Work Order ID 139761

Item Name: Fwd Crosstube - High 407

DRAWING NO. D407-667-145	TITLE CROSSTUBE ASS'Y (407 HIGH FWD)	REV. C	DART AEROSPACE LTD ENGINEERING ORDER		D.E.O. NO. D407-667-145-C-1	SHEET NO. SHEET 1 OF 1	SCALE NTS
DRAWN <i>q</i>	CHECKED <i>ASS</i>	MFG. APPR. <i>IB</i>	APPROVED <i>WD</i>		DE APPR. <i>##</i>		
DATE 11.07.15	DATE 11.07.22	DATE 11.07.22	DATE 11/07/22		DATE 11.07.21

PURPOSE:

C D407-667-145
ASSEMBLY DETAIL
(VIEW LOOKING FWD)

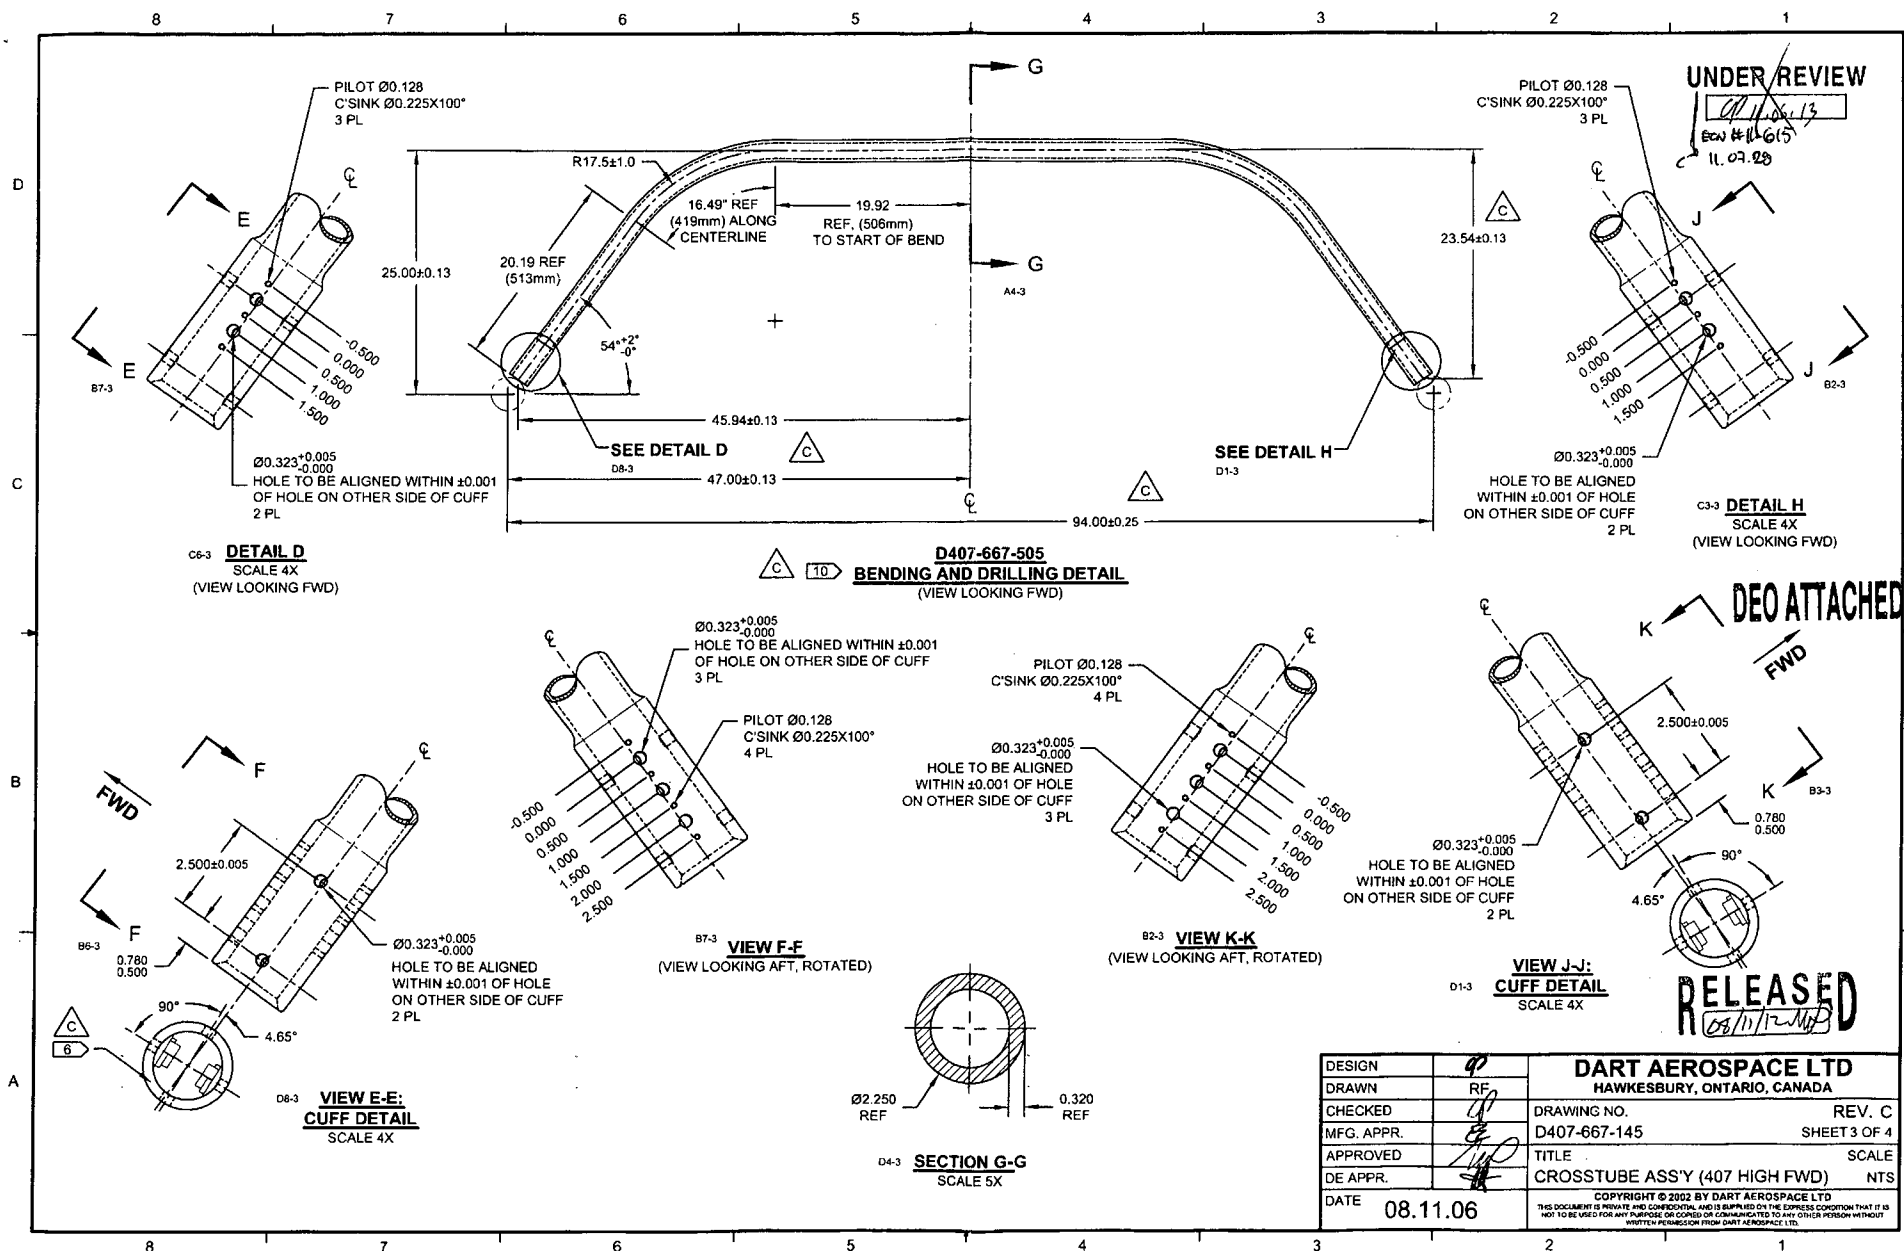
REPLACE MAGNOBOND WITH PROSEAL.

NOTE 12 & 15, SHEET 1 IS AMENDED AS FOLLOWS:

- 12) TO INSTALL D2891-1 SUPPORT: ABRASE MATING SURFACE OF SUPPORT AND CROSSTUBE WITH 180-GRIT SANDPAPER AND REMOVE RESIDUE WITH MEK (OR EQUIVALENT). APPLY A 0.04" TO 0.07" THICK LAYER OF PROSEAL 890 CLASS B-2 (OR AMS-S-8802 CLASS B-2) SEALANT TO MATING SURFACE OF SUPPORT.
- 15) TORQUE CLAMPS 80 TO 100 IN-LB. ENSURE AT LEAST 1.5 THREADS SHOWING IN SAFETY AND THAT NUT HAS NOT BOTTOMED-OUT AFTER TORQUING. **PRIOR TO PACKAGING, RE-CHECK TORQUE ON CLAMPS AFTER PROSEAL 890 SEALANT HAS CURED FOR 72 HOURS.**

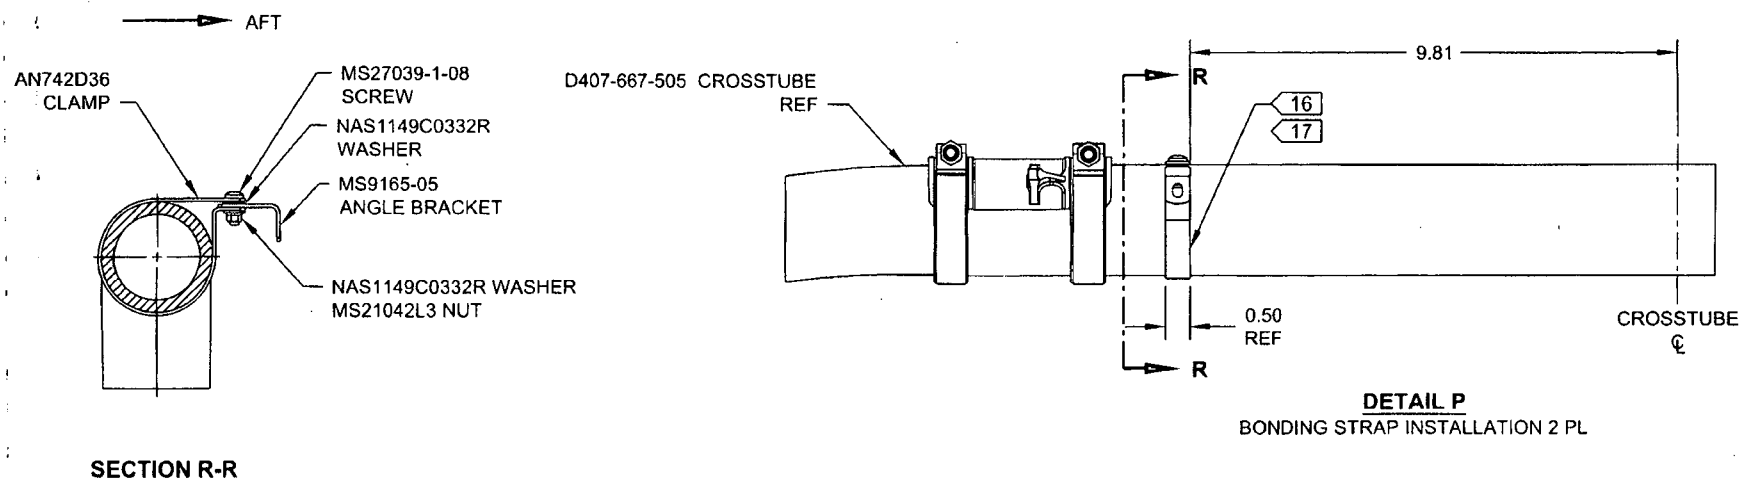
PURPOSE:

ADD ELECTRICAL GROUNDING STRAP

ITEM	QTY -145	PART NUMBER	DESCRIPTION
1	X	D407-667-145	CROSSTUBE ASSEMBLY (407 HIGH FWD)
10	2	AN742D36	CLAMP
11	2	MS9165-05	ANGLE BRACKET
12	2	MS21042L3	NUT (OR MS21042-3)
13	2	MS27039-1-08	SCREW
14	4	NAS1149C0332R	WASHER (OR AN960C10L)

DETAIL P
BONDING STRAP INSTALLATION 2 PL
